September 6, 2012

ECS Project # 03-216630.00

Re: Response to Questions- Risk Based Site Cleanup and Disposal Plan
Thomas Prince School
170 Sterling Road
Princeton, MA 01541

Figure 1: Typical Exterior Vent Structure: 100 Wing Classrooms.

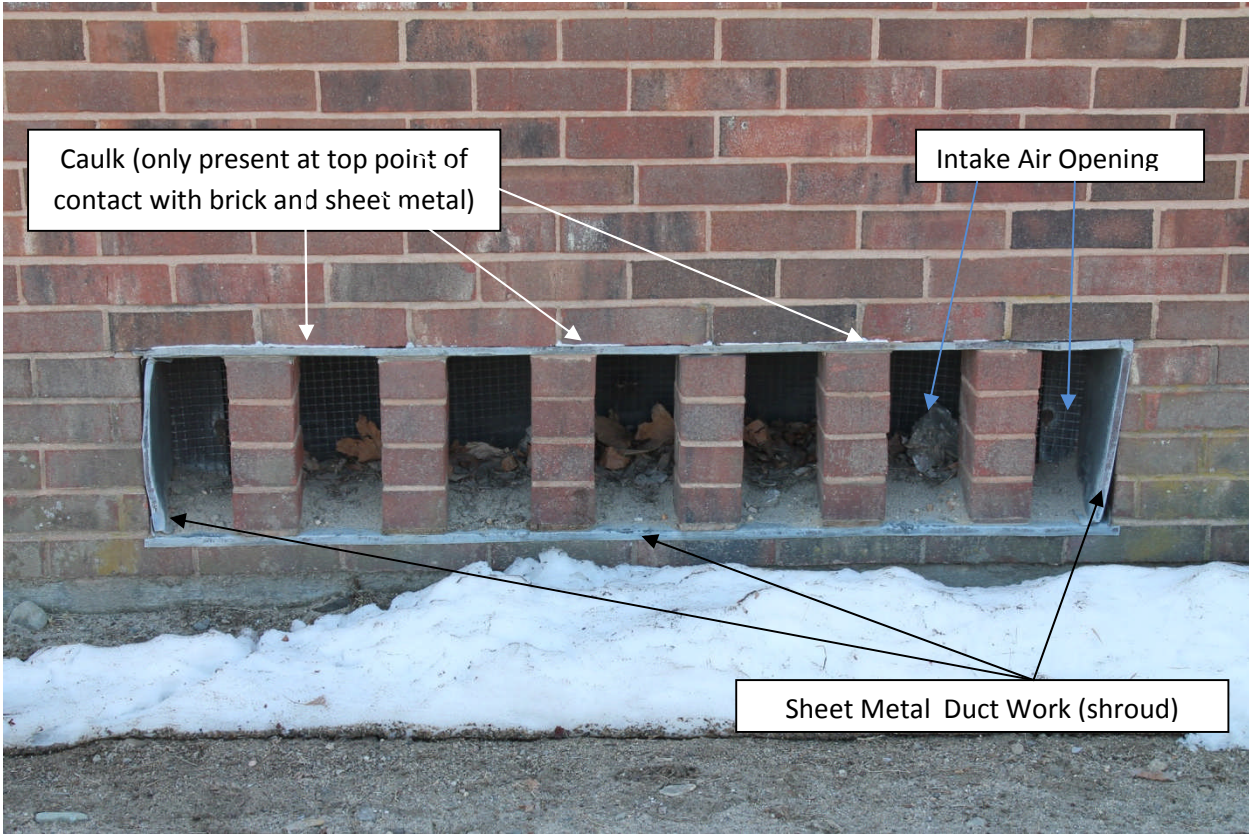
Air Intake Vents – 100 Wing Classrooms – Prior to and following the meeting which I attended at the school yesterday, ECS and TEI closely inspected the air intake vents for the subject 100-Wing classrooms. See the attached photo, Figure 1, for a depiction of a typical vent for the subject 100-Wing Classrooms.

A typical vent opening is 54 inches wide by 8 inches in height. It is located on the bottom vertical side of the building and does not contain a louvered plate over its front but rather is open in the front, divided by several, eight inch high by two inch wide brick columns. Sheet metal ducting lines the interior of the vent and is supported in the front opening by the brick columns. The sheet metal ducting extends contiguously into the unit ventilator. Where it comes in contact with the exterior brick face of the building facade, it is crimped at a 90° angle to overlap the exterior building brick face by approximately ½ inch on all four sides. It was determined that caulking is only present at the top of the ducting of each exterior vent opening where the sheet metal duct work comes in contact with the brick, i.e. the side and

bottom joints do not contain caulk and no remnants of caulk were observed. The unit ventilator draws its room dilution air from this vent opening.

Following is the plan, in order of operation, to address these exterior vent openings as part of the previously submitted modification.

- 1) All exterior caulk associated with the vents will be removed (this will be approximately 22.5 linear feet based on caulk only being present at the top of the vent as recently confirmed);

- 2) The ½ inch of sheet metal that is crimped at a 90° angle parallel with the brick face, on all four sides, will be bent back so that it is perpendicular to the brick face. This will provide access to the small gap between the brick and the sheet metal for cleaning and epoxy coating;

- 3) The gaps between the sheet metal and brick will be suctioned with a HEPA vacuum to remove loose residual debris that may be present;
- 4) The readily accessible inner surfaces of the duct work, at and within the opening of the air vent, will be cleaned via HEPA vacuum to remove dust, dirt or debris;

- 5) The readily accessible surfaces of the sheet metal duct work and brick that were in contact with the caulking will be cleaned via wet wipe methods;

- 6) The readily accessible inner surfaces of the duct work, at and within the opening of the air vent, will be cleaned via wet wipe methods;
- 7) Two coats of epoxy will be applied to the accessible surfaces of the brick to a distance of eight inches (four brick widths) from each side of the vent, consistent with the previously approved distance for the 200-Wing rooms). In addition, two coats of epoxy will be applied to the brick surfaces that are perpendicular to the brick face wall at a distance of approximately ½ to 1 inch at the corners of the brick surface that extend below the metal duct work;

- 8) The edges of the sheet metal duct work, adjacent to the exterior brick building façade, will be bent back to their original positions such that approximately ½ inch of sheet metal will cover the edges of the epoxy coated brick at the openings of the air vents.

Figure 2: Typical Exterior Louvered Vent Structure: 200 Wing Classrooms.

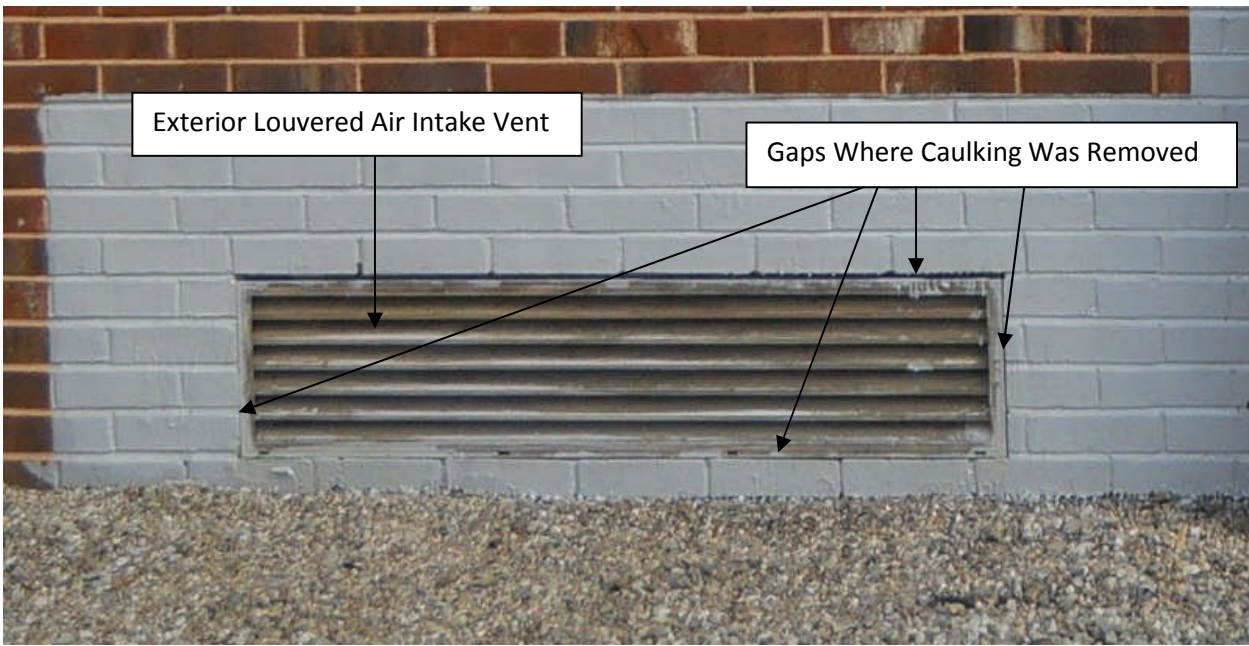
Air Intake Louvered Vent Covers – 200 Wing Classrooms – As we discussed on Tuesday, the approved Risk Based Site Cleanup Plan for the 200-Wing exterior metal louvered air intake vent covers provided for the removal and replacement of the covers (section 4.4, bullet one of the February 13, 2012 Risk Based Cleanup Plan). Due to an oversight, the vent covers were not removed. Following the meeting at the school yesterday, ECS and TEI closely inspected several of the exterior louvered air intake vent covers for the 200-Wing classrooms. Review of field notes and a discussion with the TEI Field Supervisor were also performed to confirm the actions that were taken to address the metal louvered vent covers. Based on a review of available information and discussions with TEI, it was confirmed that the following actions were taken in response to the exterior louvered vent covers:

- a) All visual exterior caulking was removed;
- b) The outer sides of the louvered vent covers (sides facing away from the building) had been cleaned via HEPA vacuum and wet wipe methods (the inner sides of the vent covers (facing the building) had not been cleaned);

- c) Two layers of epoxy were applied to the brick face within 8 inches of each side of the louvered vent covers.

As a modification to the plan, ECS proposes to collect three wipe samples, per required EPA methodology, and submit the samples for analysis via EPA Methods 3540C and 8082 for PCB's. It is proposed that one sample each be collected from three of the six existing inner sides of the louvered vent covers. If the result of a wipe sample for a particular louvered vent cover is greater than 1 ug/100cm² PCB, that louvered vent cover will be removed and cleaned via HEPA vacuum and wet wipe methods or replaced with a new cover.

If the cleaning option is selected, upon cleaning, another wipe sample will be collected from the inner side of the vent. If the sample result remains greater than 1 ug/100cm² PCB, the louvered vent cover will again be cleaned via HEPA vacuum and wet wipe methods or replaced with a new cover. Any cover that produces results less than 1 ug/100cm² PCB will remain in place or be reinstalled (if it was removed for cleaning and re-sampling). This procedure will continue until either a result of less than 1 ug/100cm² PCB is obtained for a particular vent cover or until a new cover is obtained. The decision to resample or replace a cover will be made by the Town of Princeton. See the attached photo, Figure 2, for a depiction of a typical exterior louvered vent cover for the 200-Wing Classrooms.
